**THFC Hotel S73 Application – Wind Microclimate Review**

**Northumberland Development Project – Section 73 Application  
Wind Microclimate ES Addendum Review**

Figure 6 – CFD predictions of worst-seasonal comfort within the playground of St Francis de Sales Junior School.

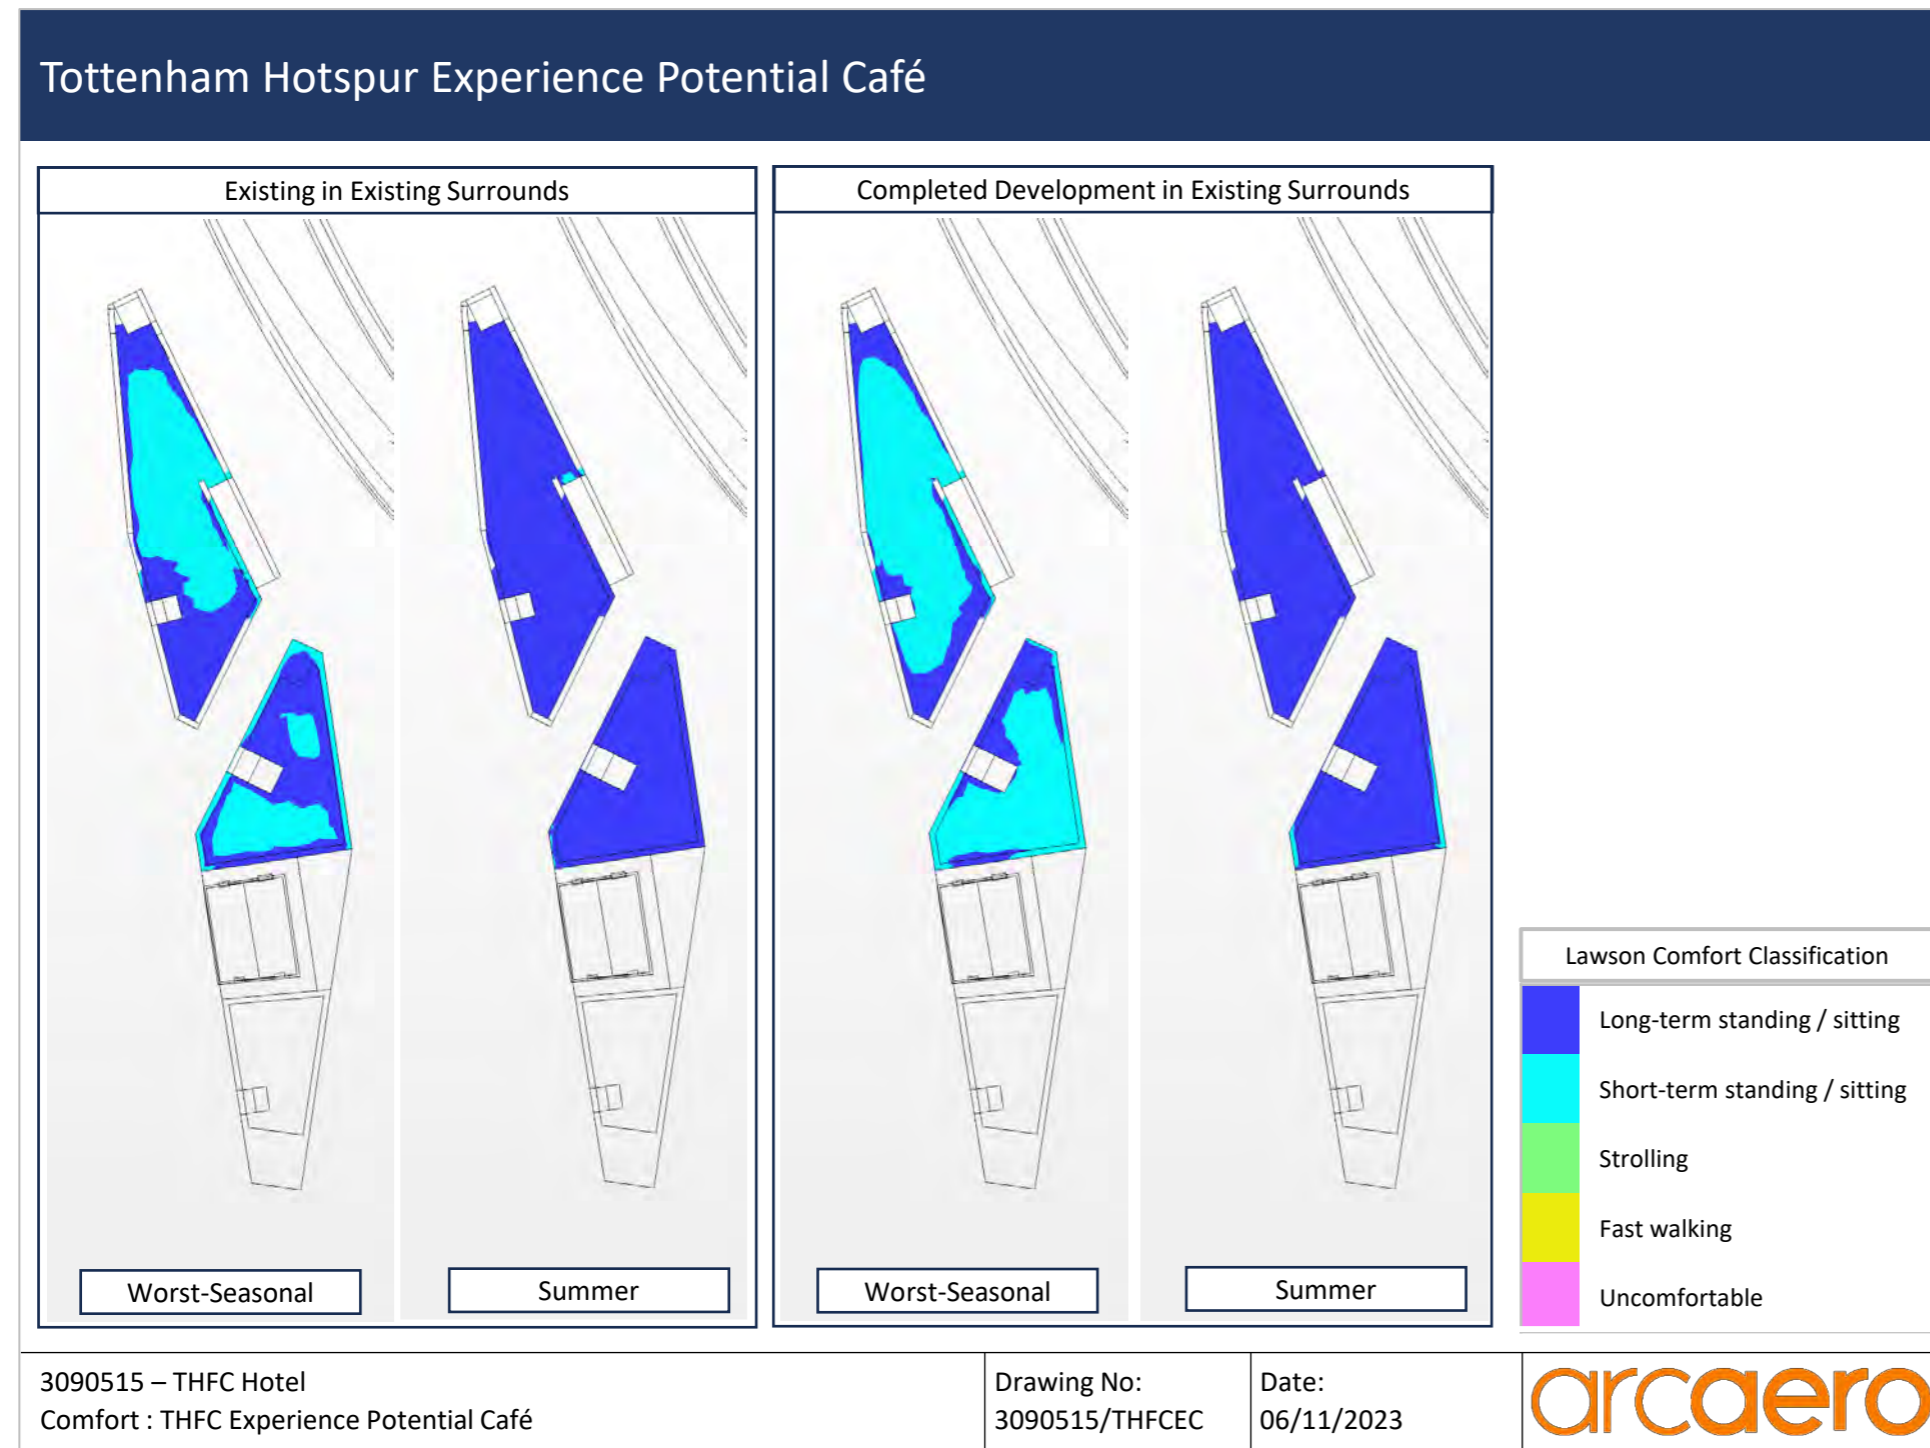
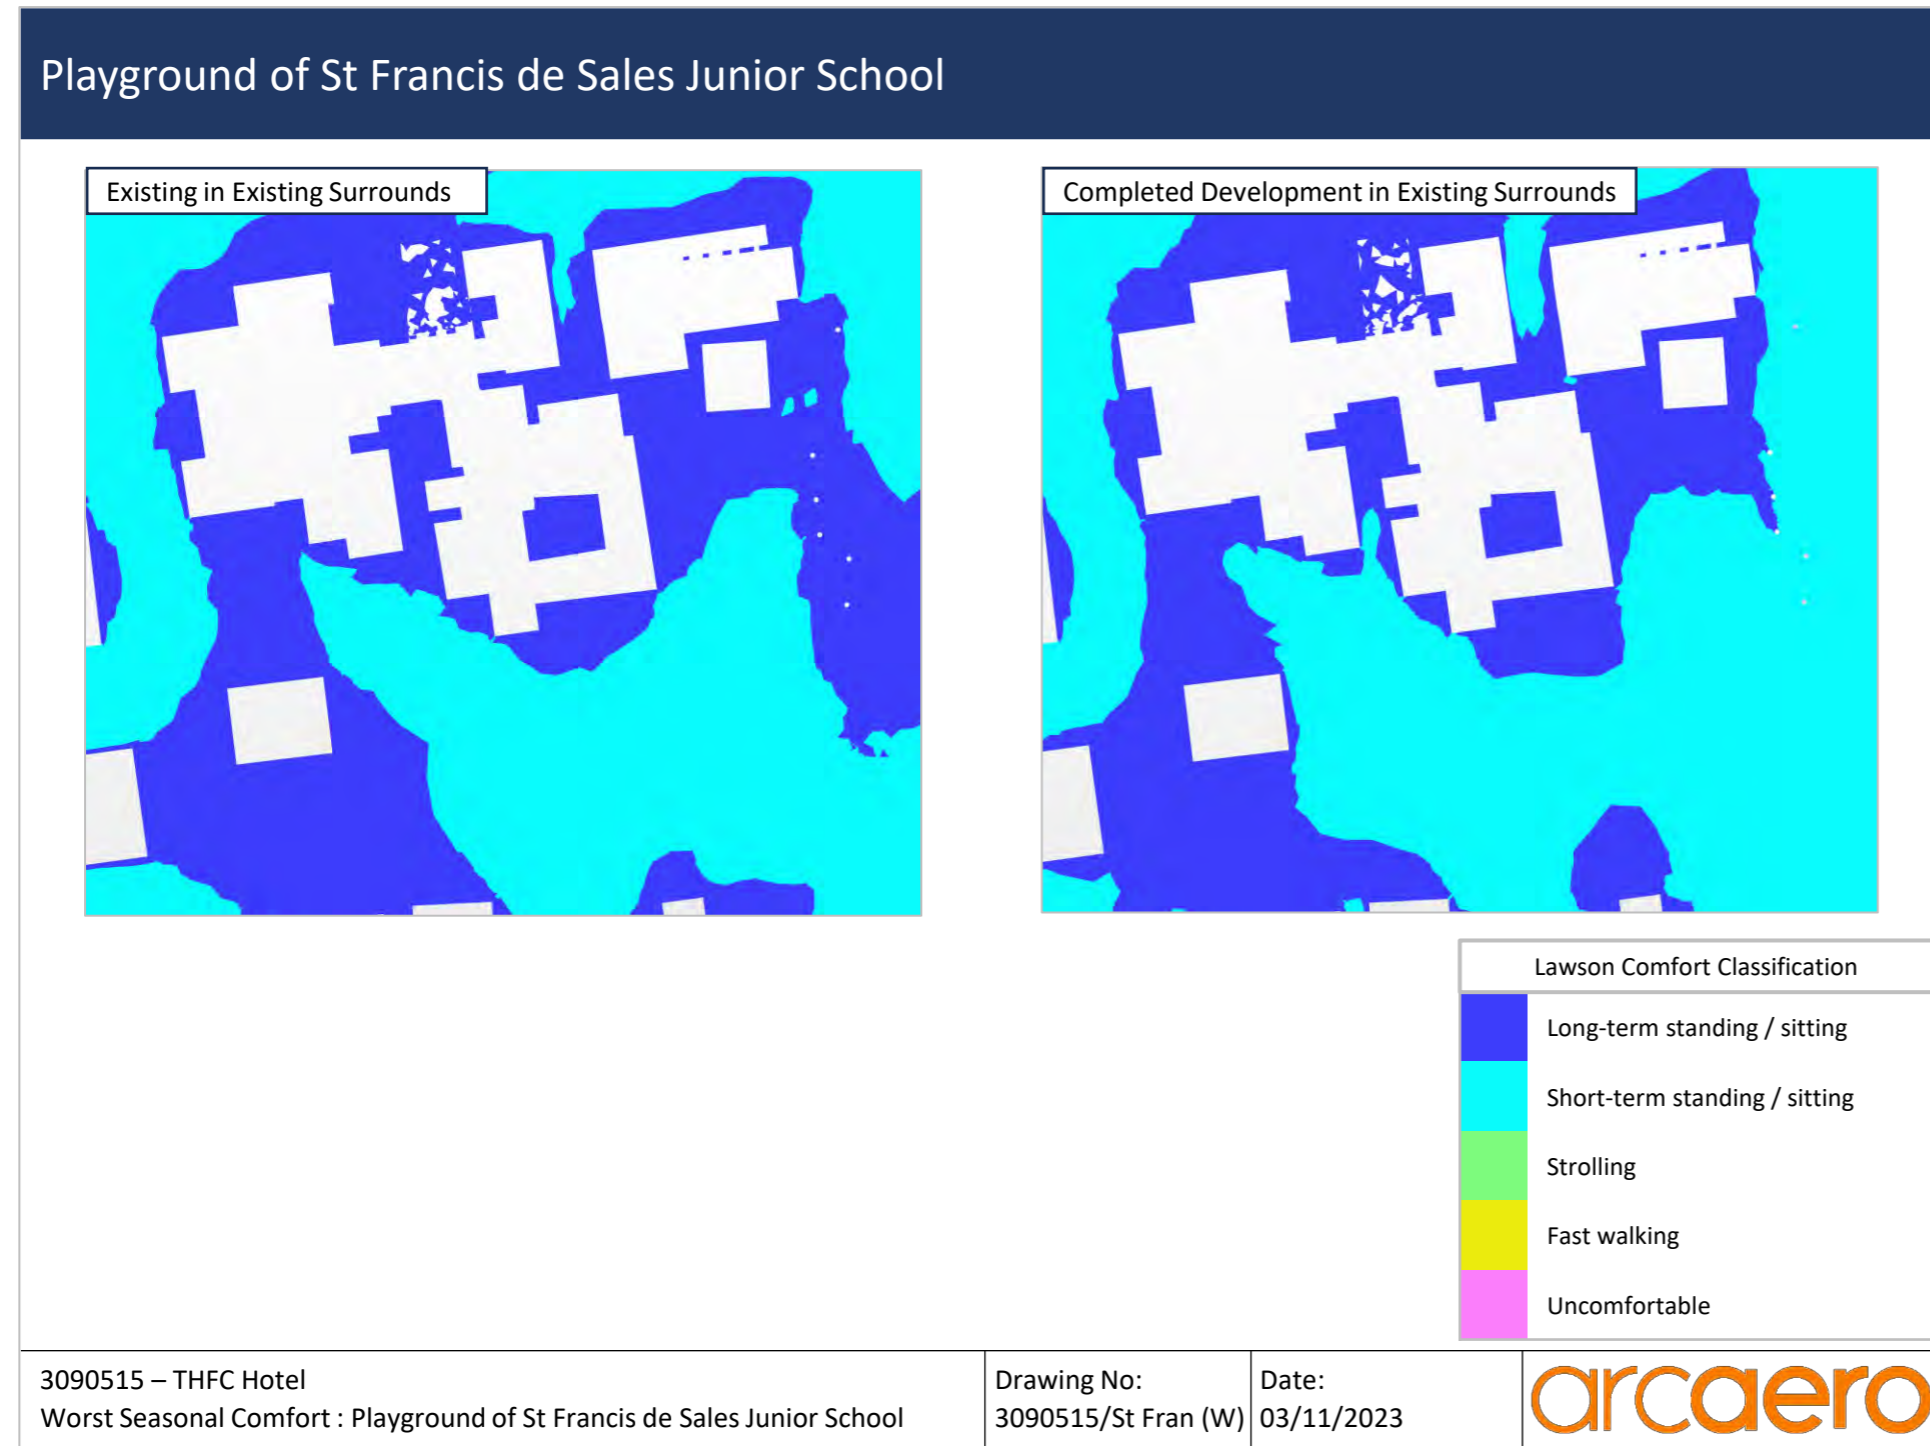
- The Dare Skywalk;
- Podium level entrances and potential cafe outdoor seating for the Tottenham Experience;
- The playground of St Francis de Sales Junior School; and
- Commercial and residential entrances and private gardens along Park Lane.

Podium level entrances and potential cafe outdoor seating for the Tottenham Experience	Please see Figures 4 and 5 that present baseline CFD contours for the Plot 4 Tottenham Hotspur Experience.  Entrance conditions are suitable for short-term standing / sitting in the worst season and thus suitable for ingress / egress. This includes the entrance to the Dare Skywalk reception (the northernmost entrance) which is recessed behind the building line.  It is understood that potential café seating refers to the roof to the north of Warmington House. Here conditions are predicted to be suitable for short-term standing year-round and for long-term sitting in summer.
	The playground of St Francis de Sales Junior School	Please see Figure 6 that presents baseline worst seasonal CFD comfort contours for the school playground.  Baseline conditions are suitable for a mixture of short-term and long-term standing / sitting throughout the year and are correspondingly suitable for a general / active recreational area such as a school playground.

Figure 7 – Park Lane south, CFD predictions of worst-seasonal comfort

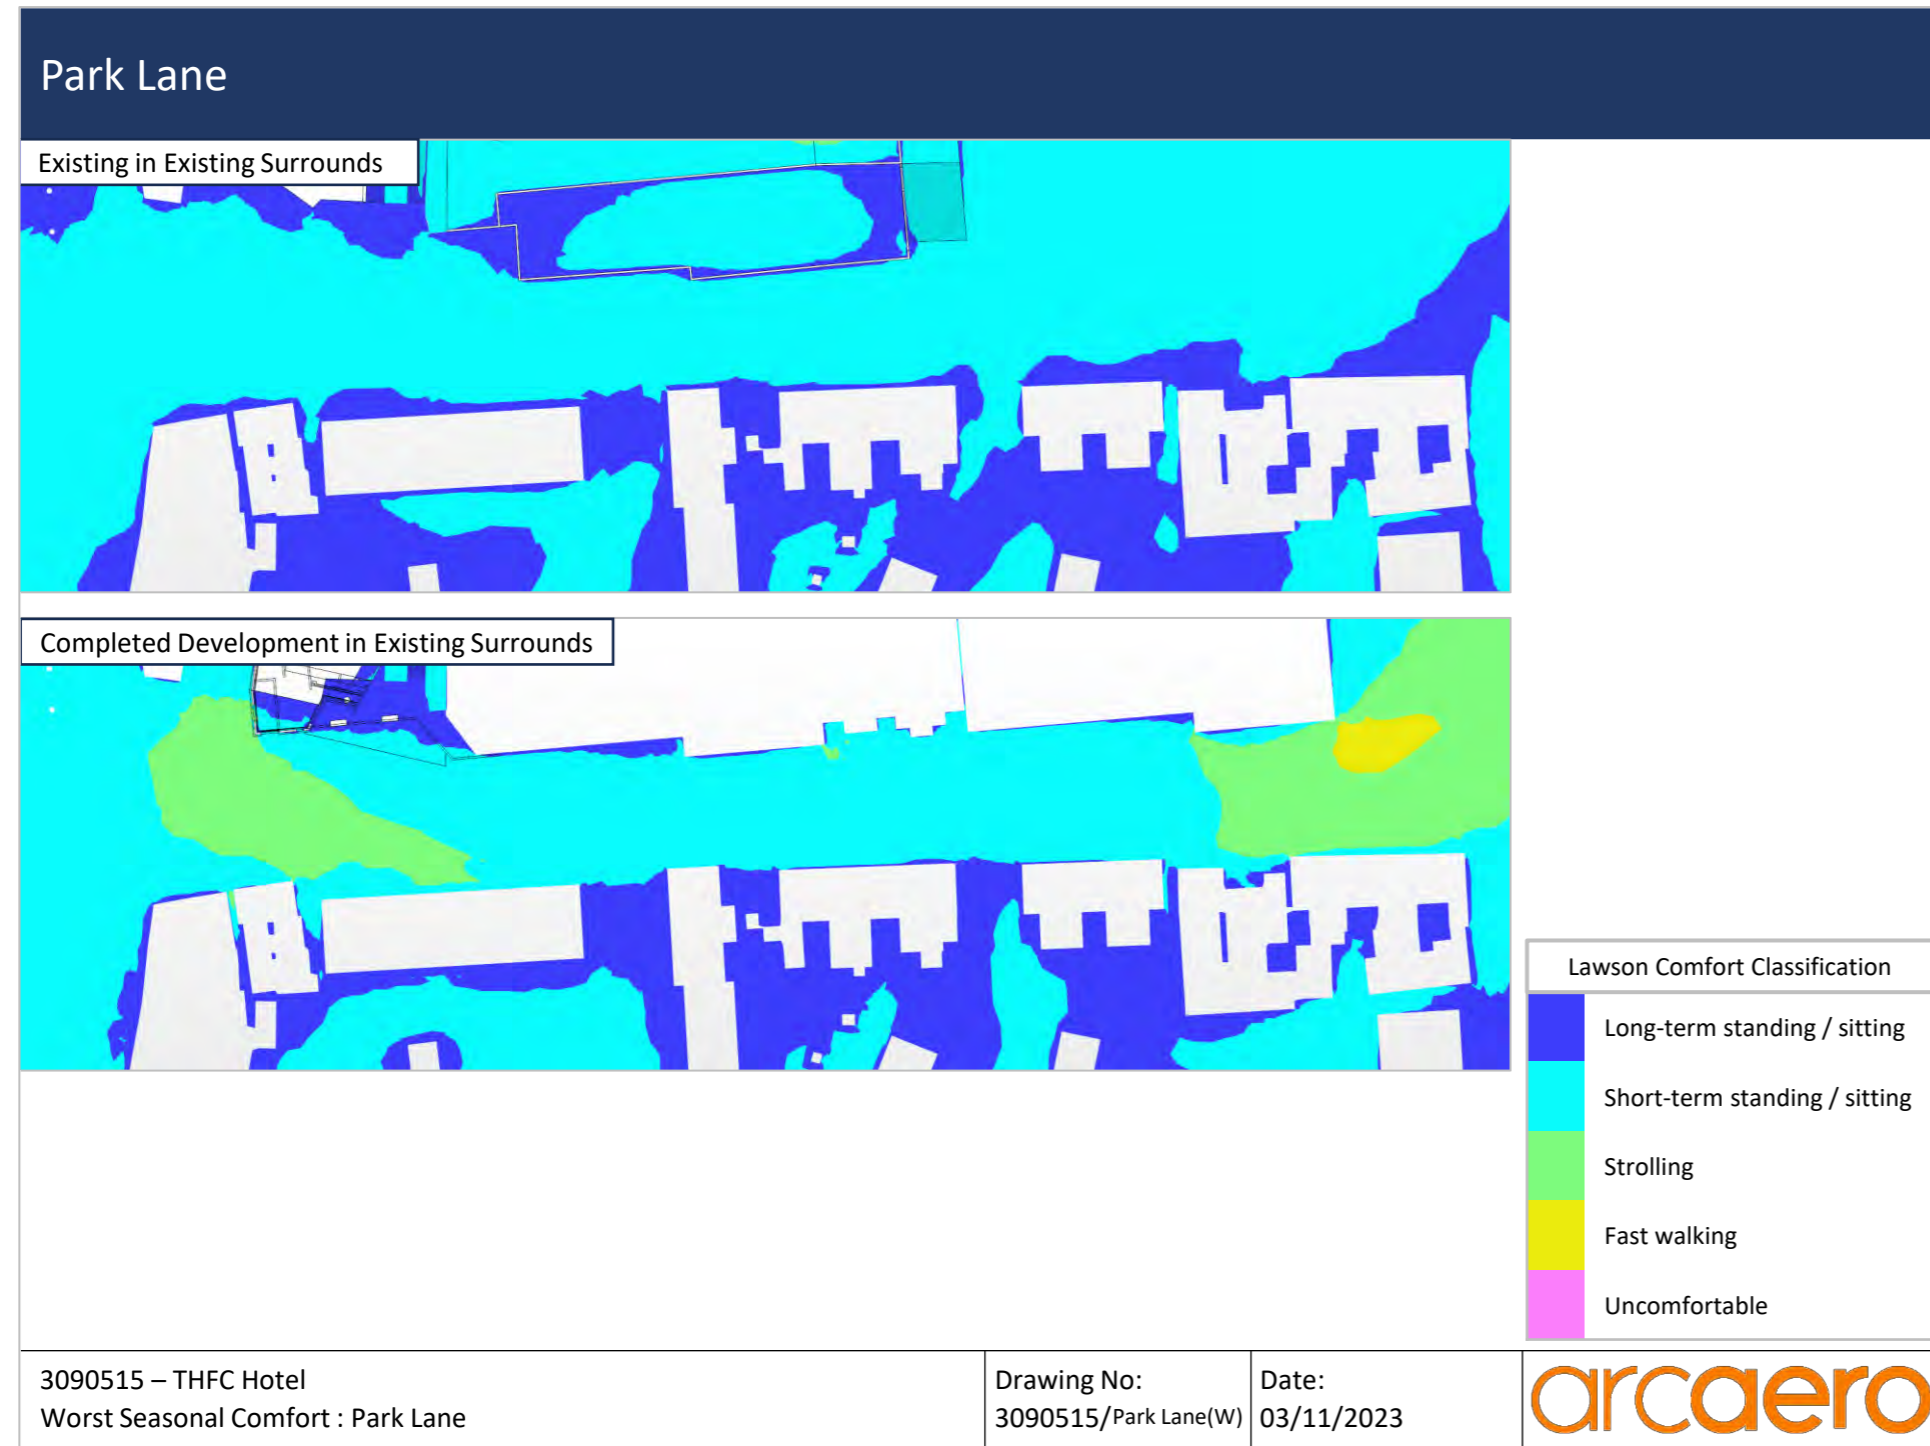
- Commercial and residential entrances and private gardens along Park Lane.
8. clarify the proposed usages of the proposed Hotel amenity spaces, the wind mitigation measures implemented and the resulting suitability of wind conditions;

<p>Commercial and residential entrances and private gardens along Park Lane</p>	<p>Please see Figure 7 for worst seasonal CFD comfort contours for this area, and please also refer to the wind tunnel results.</p>

<p>For the completed Development, conditions at the immediate frontage of properties along Park Lane are predicted to be suitable for short-term standing or better in the worst-season, this without the presence of the numerous private residential boundary walls and fences that would serve to locally slow wind travelling along Park Lane. Private gardens to the rear of the properties continue to be substantially suitable for long-term sitting in the worst-season, and of course better in other seasons. This represents a negligible effect of the completed Development.</p>
--	--	--
